North Campus Faculty Housing Phase II  
Project No. FM110407L/986315

**Addendum No. 6**

ADDENDUM NUMBER 6  
to the  
CONSTRUCTION DOCUMENTS

BUILDING 600A : SECTIONS 2

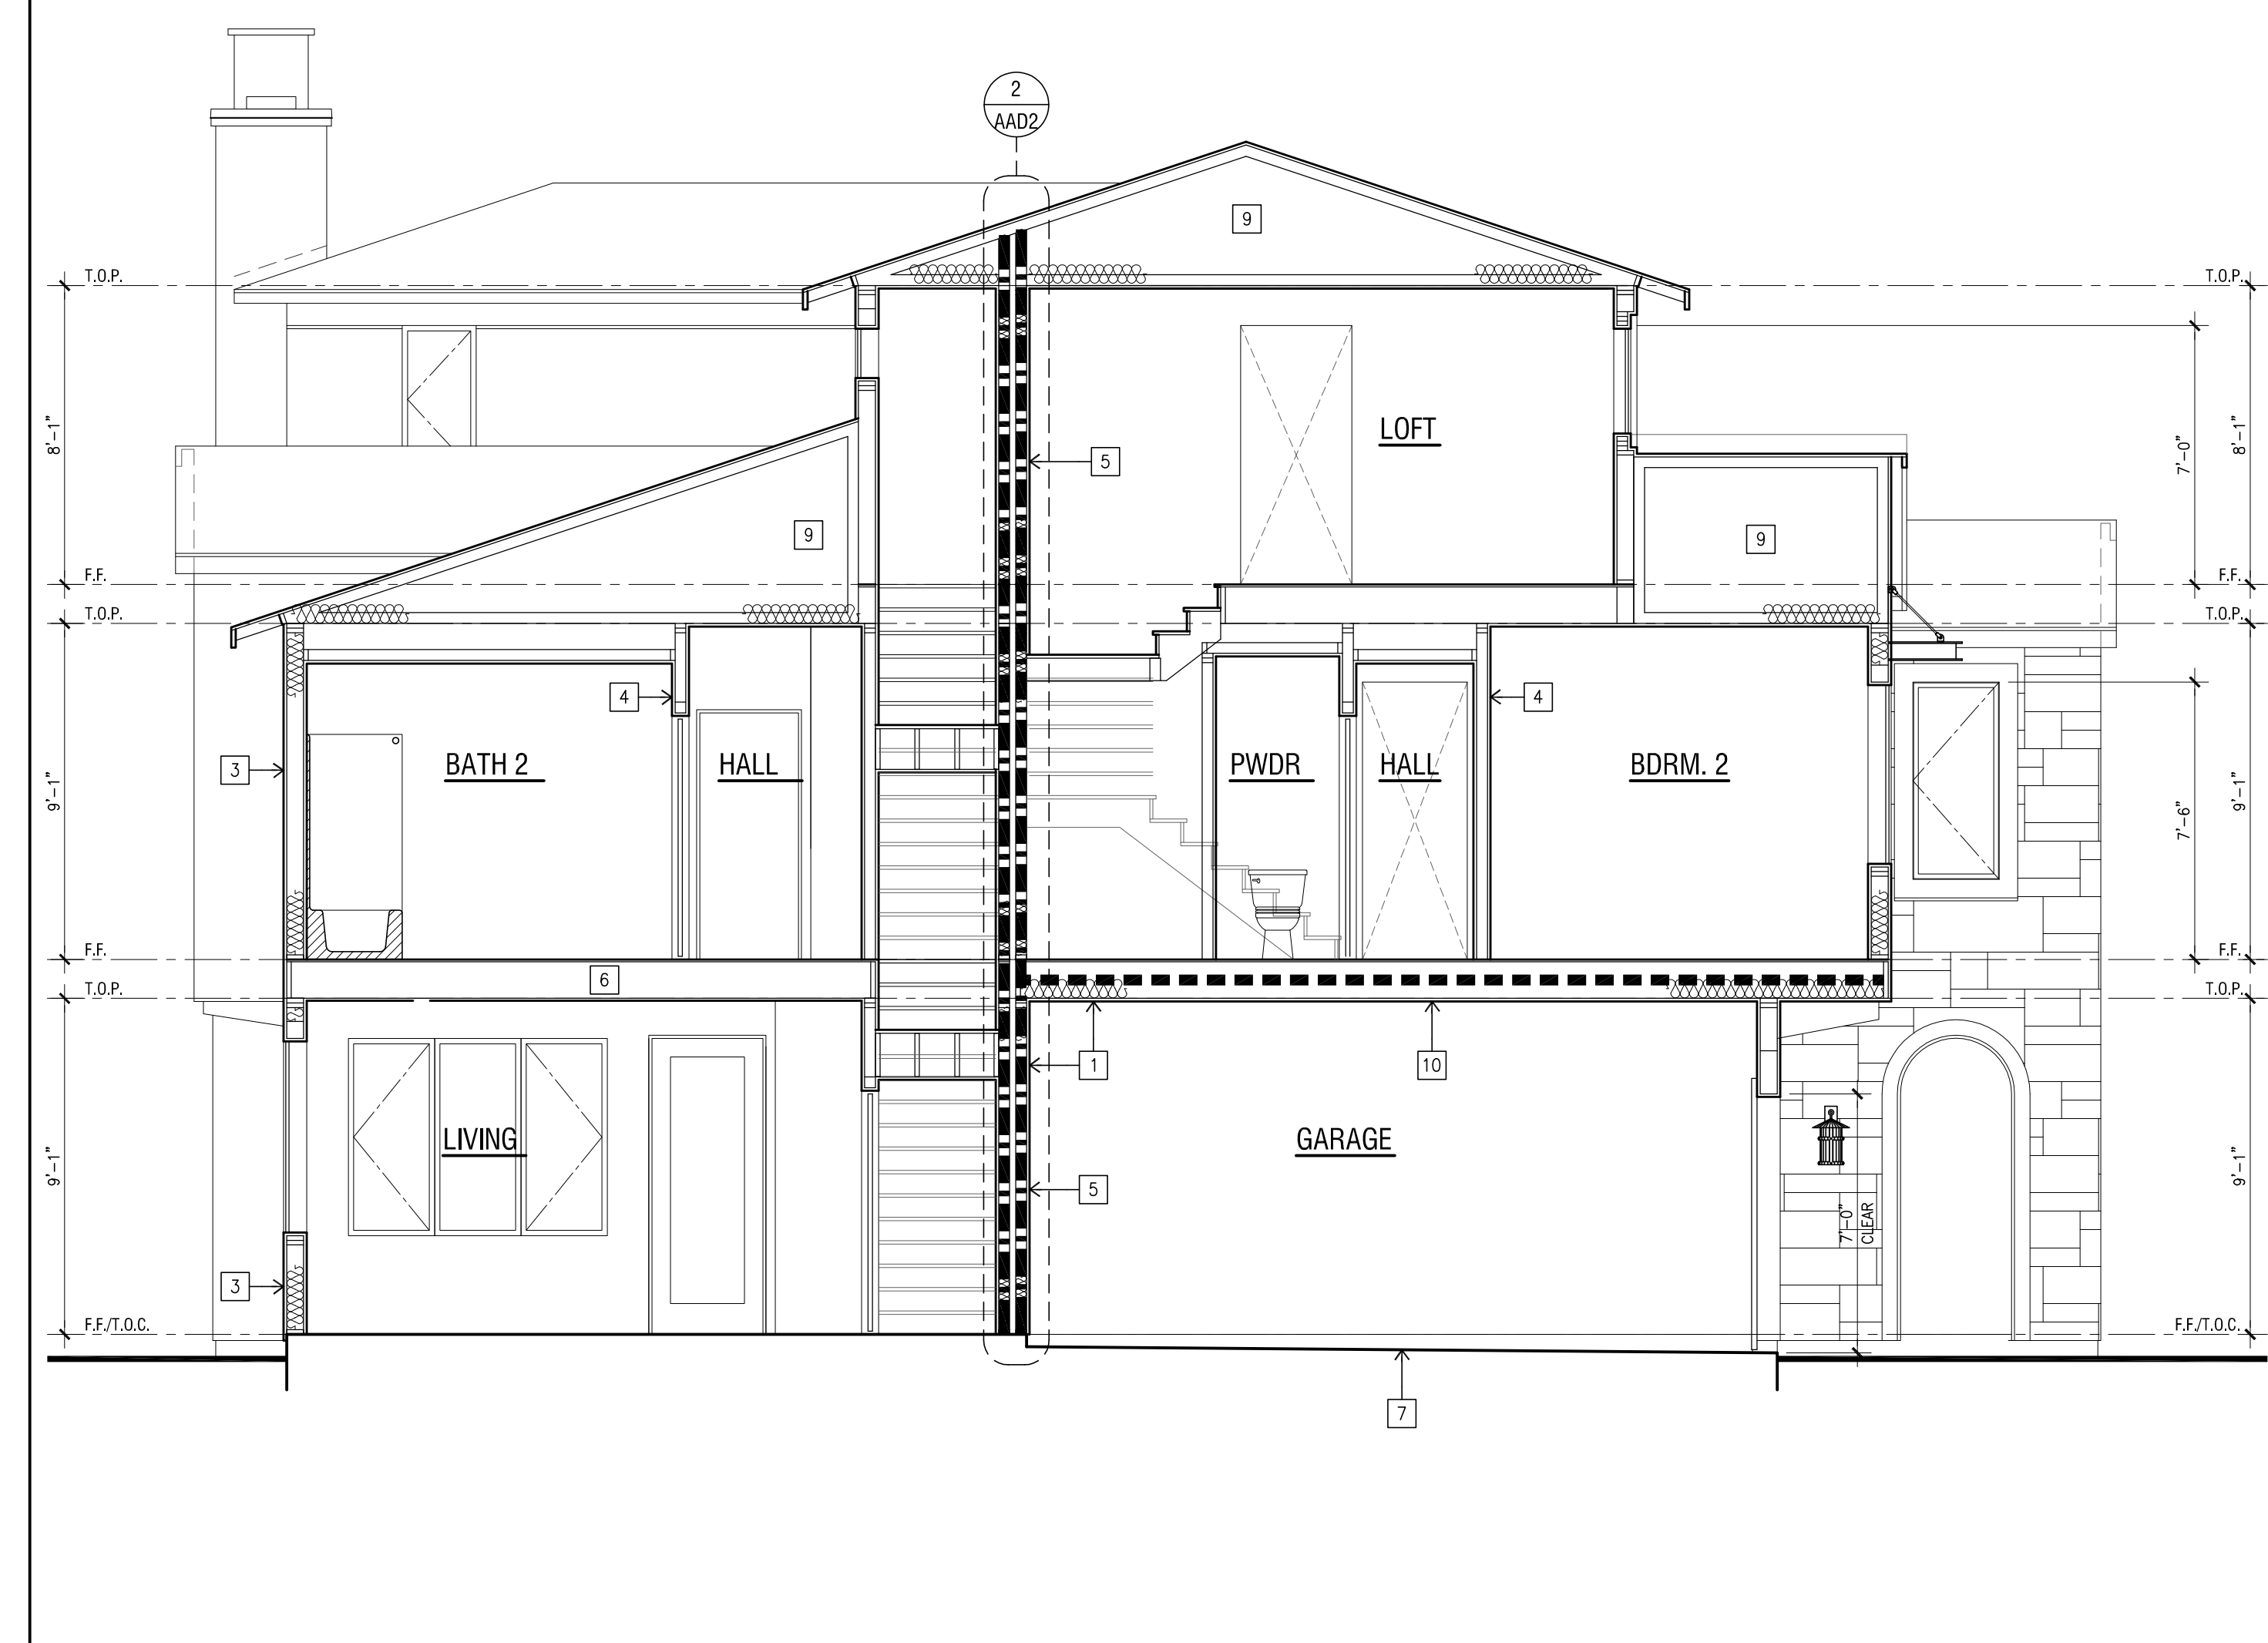
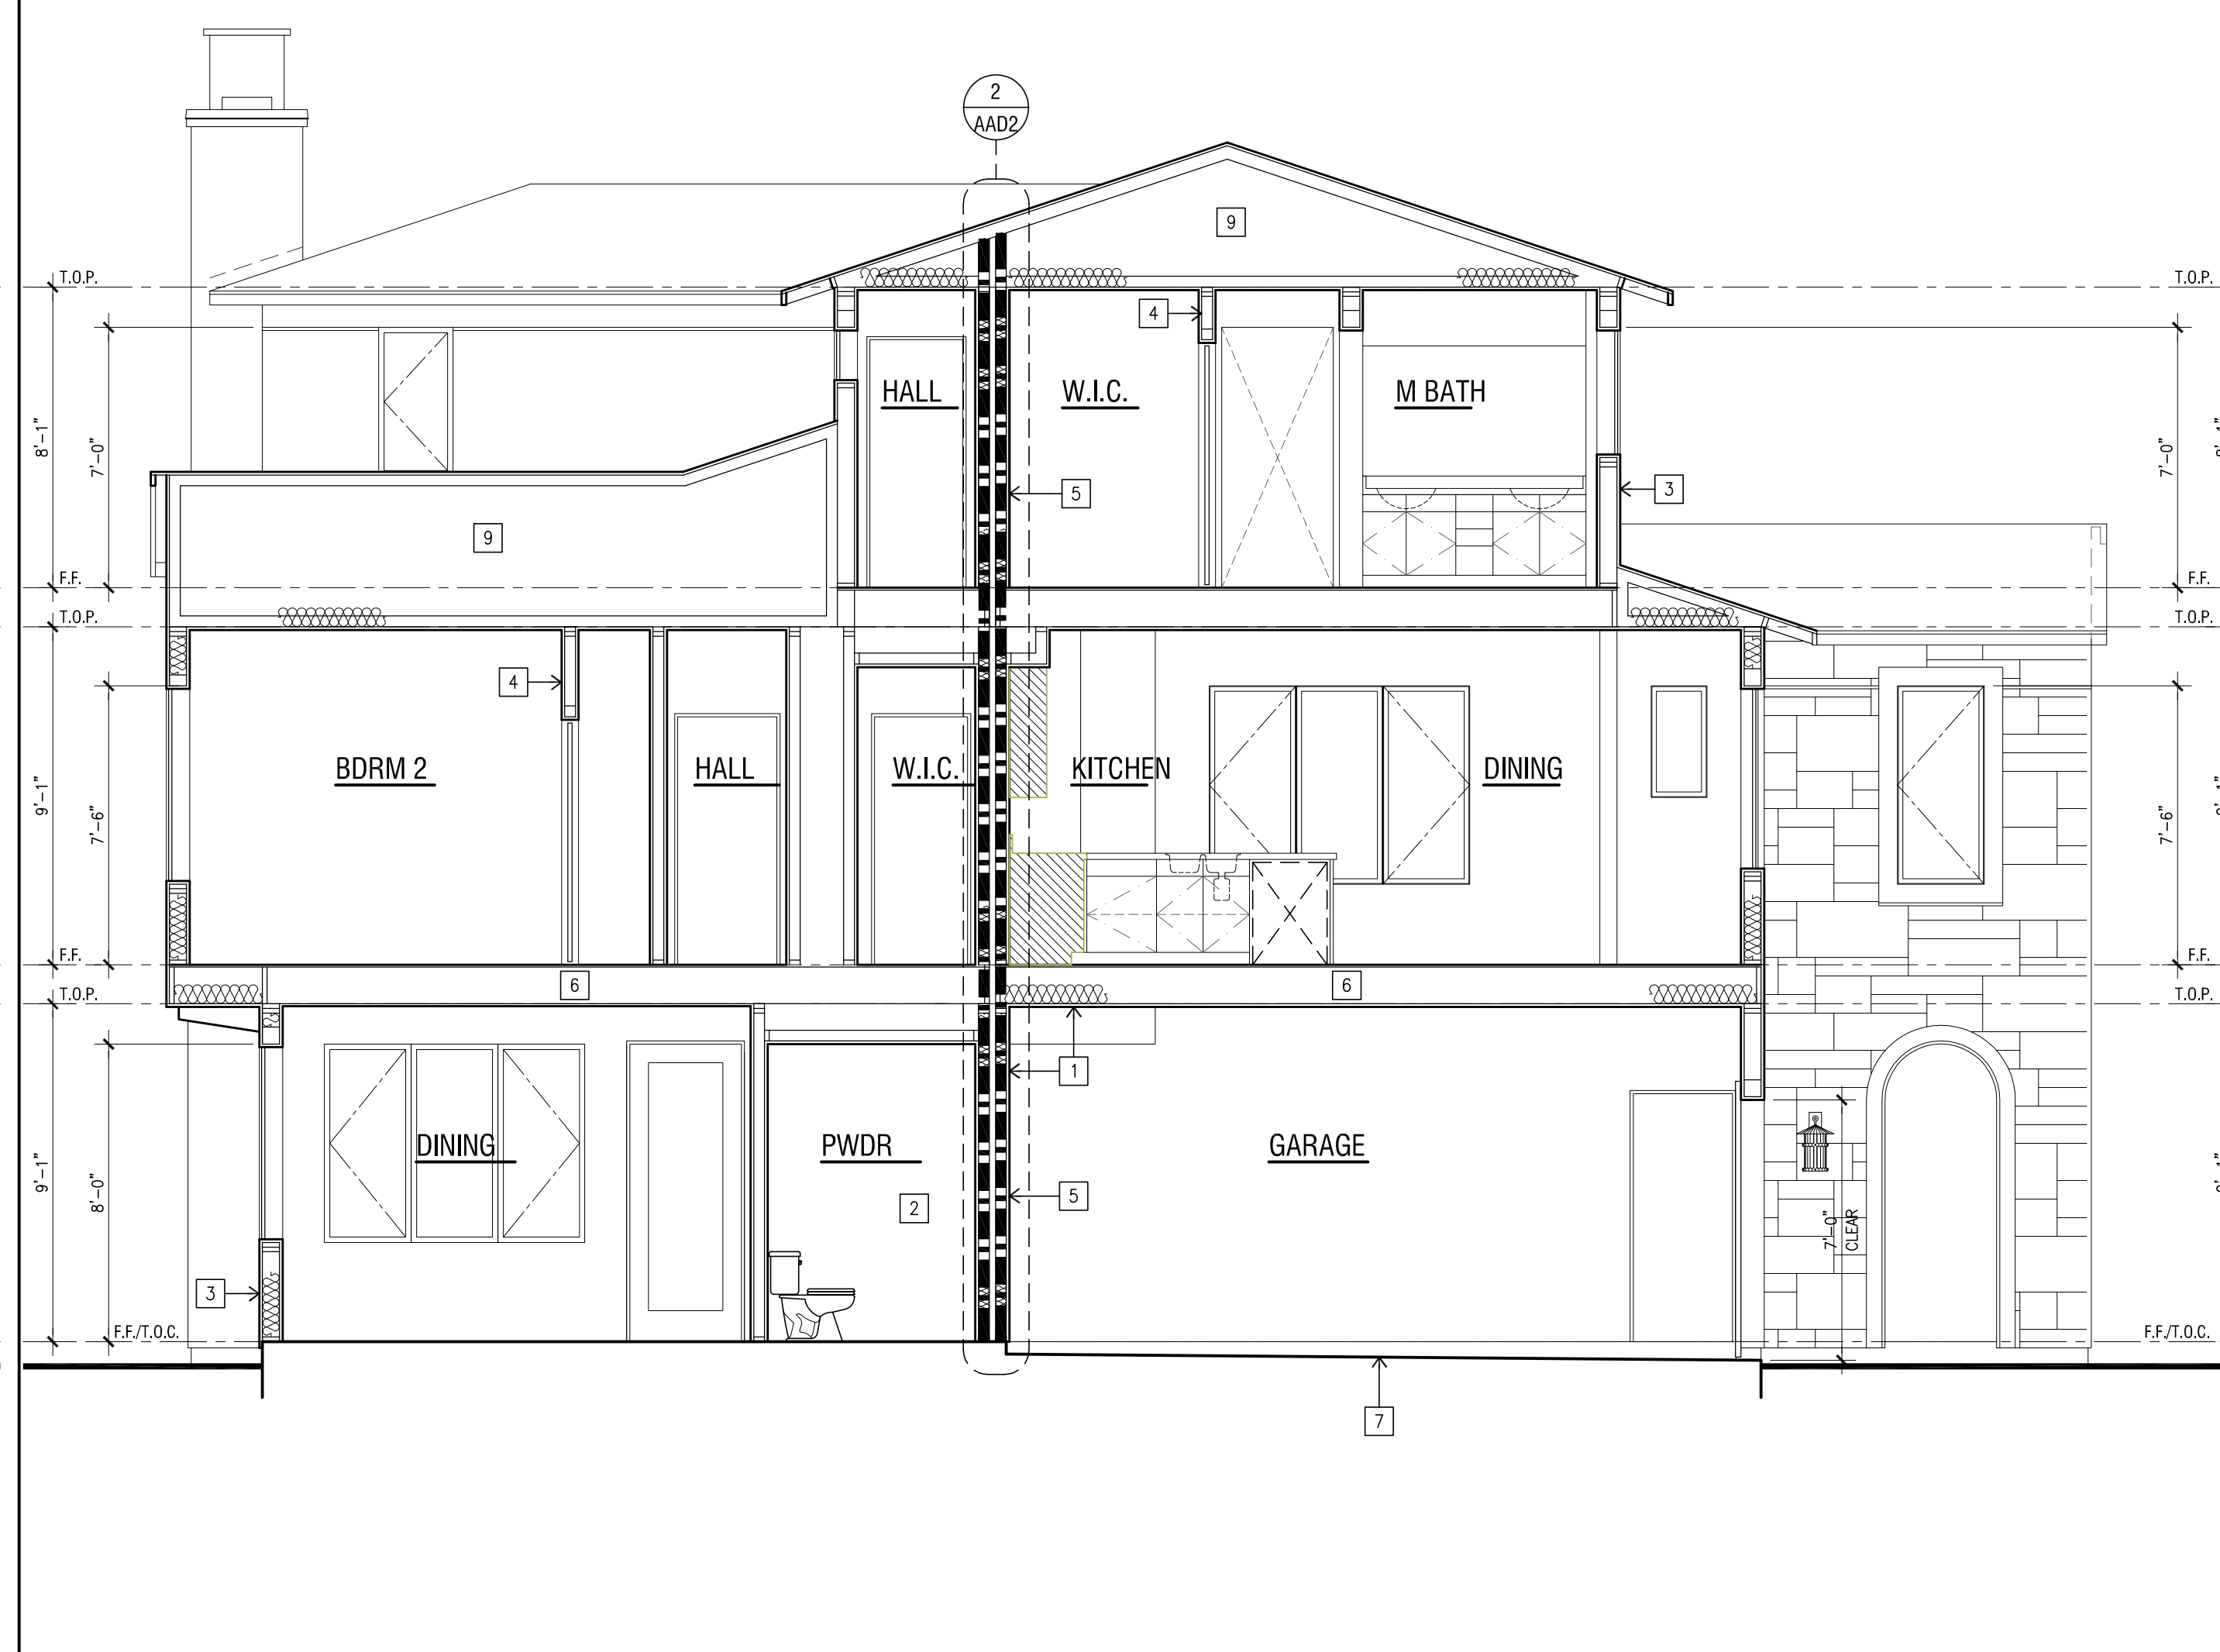
1. **Add** the attached Architect Sketches 1 of 8, dated 9/23/11.  
Sketch 1 of 8 Building 400A: Sections  
Sketch 2 of 8 Building 400B: Sections  
Sketch 3 of 8 Building 500B: Sections  
Sketch 4 of 8 Building 600A: Sections
